HISTORIC LANDMARK COMMISSION
APRIL 22, 2013
CERTIFICATE OF APPROPRIATENESS
LHD-2013-0003
4205 Avenue H
Hyde Park Local Historic District

Construct a new house on a lot with a two-story contributing garage.

1 NORTH ELEVATION

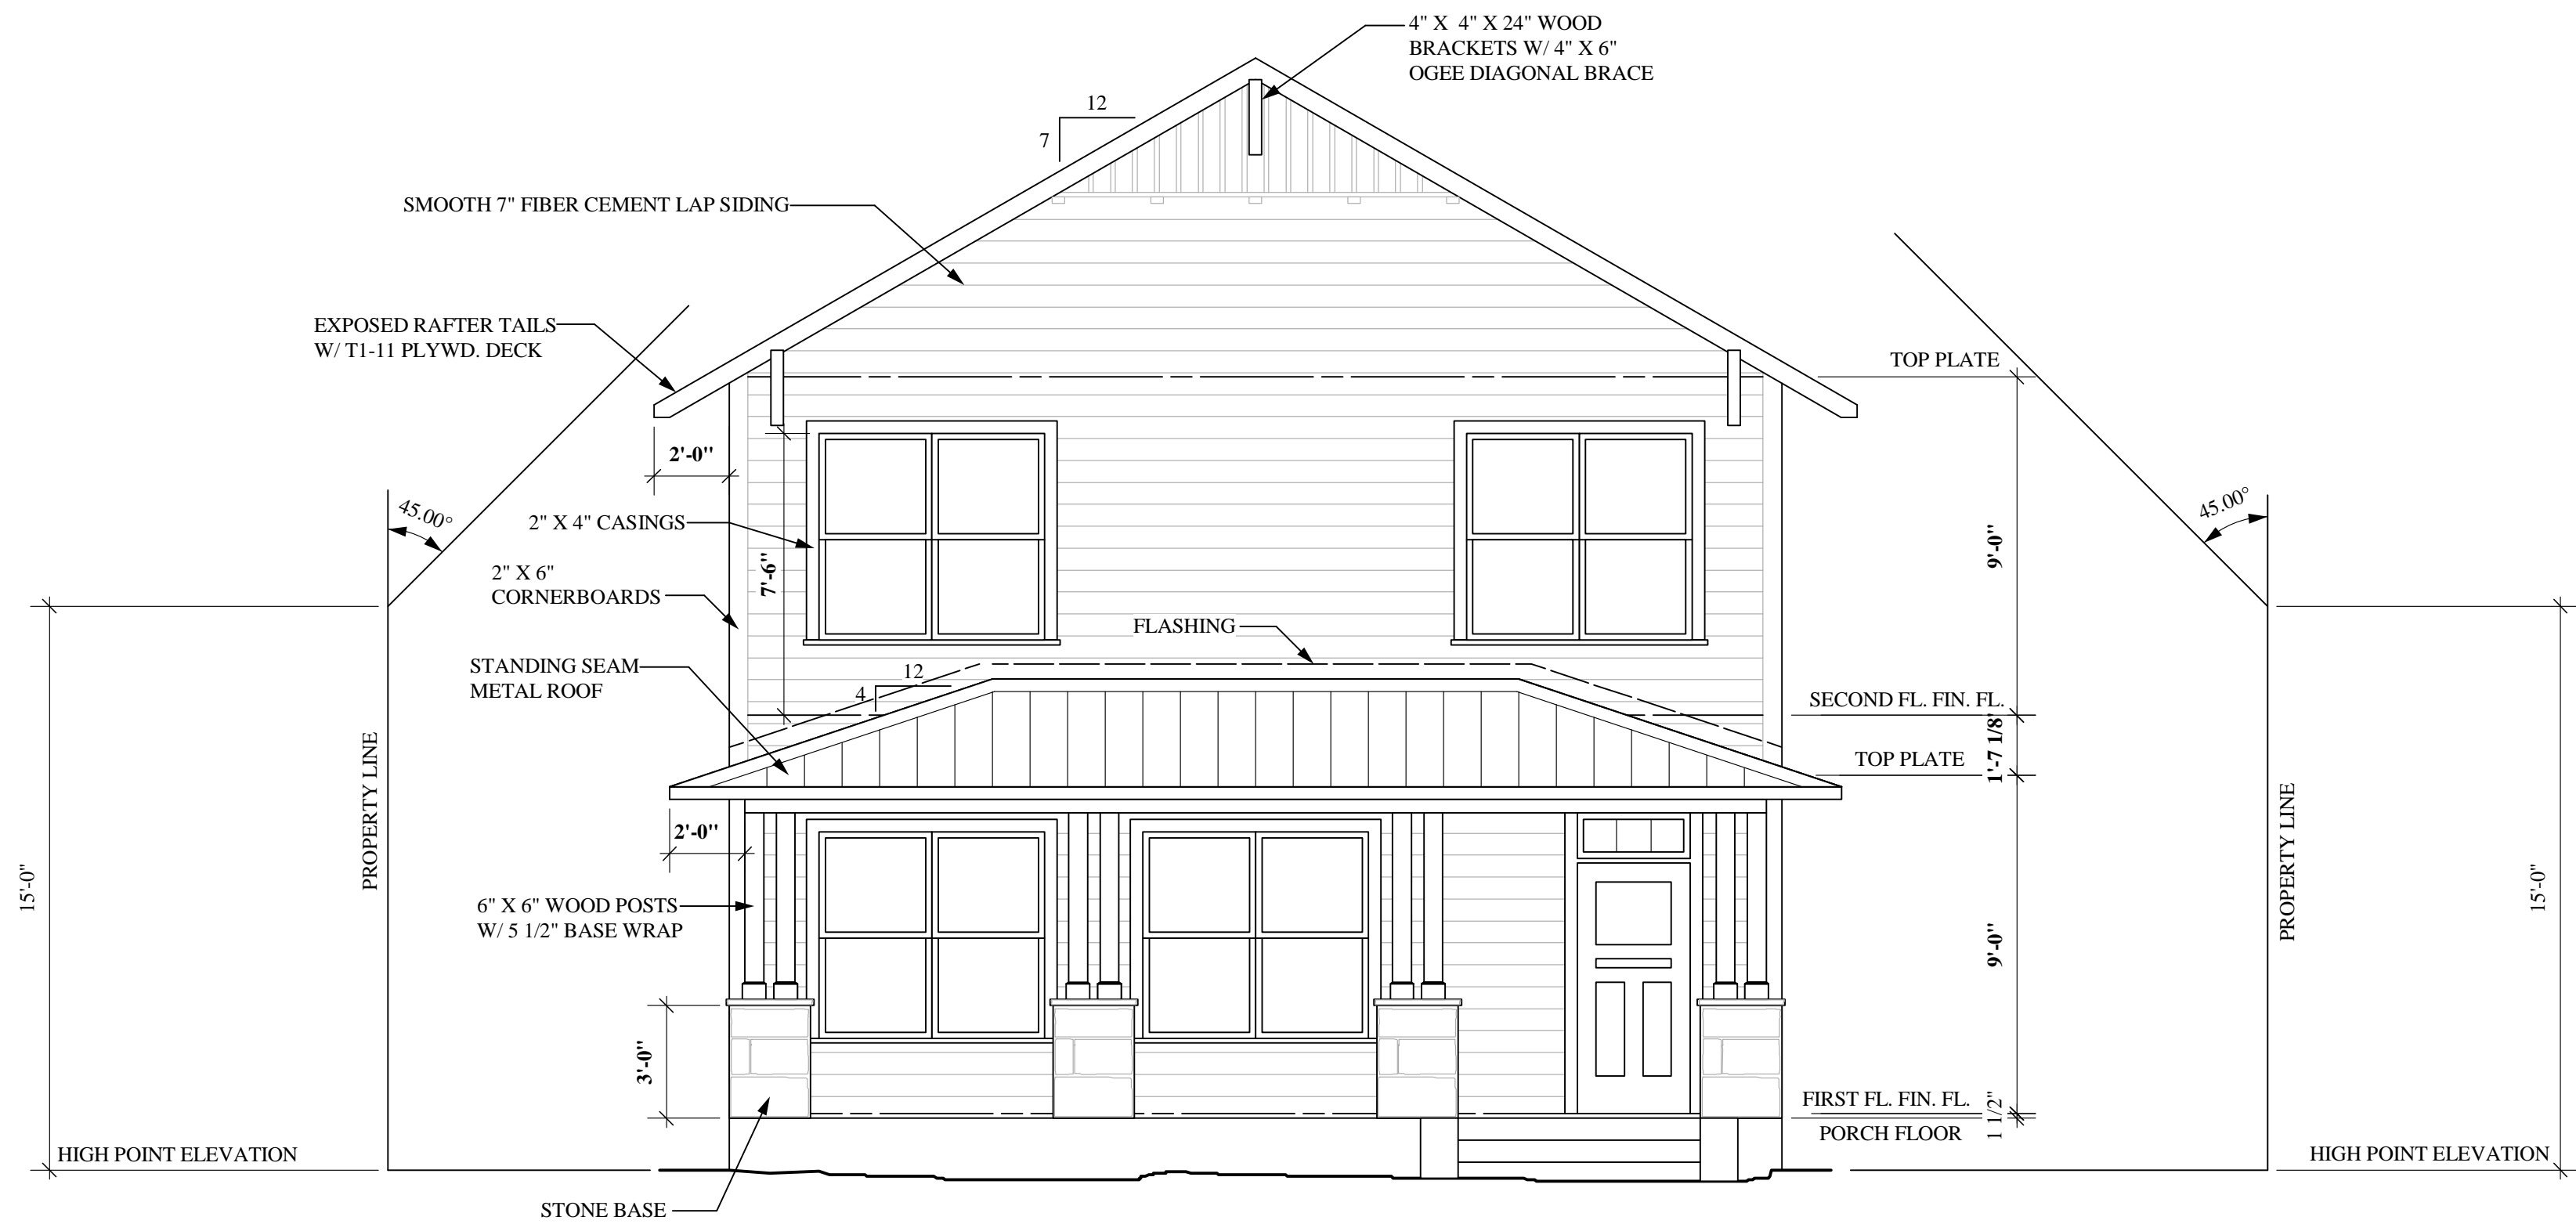
The applicant has agreed to incorporate the Certificate of Appropriateness Review Committee's recommendations to provide trim between the pairs of double-hung windows to approximate weight pockets.

Provide trim between the pairs of double-hung windows to approximate weight pockets.
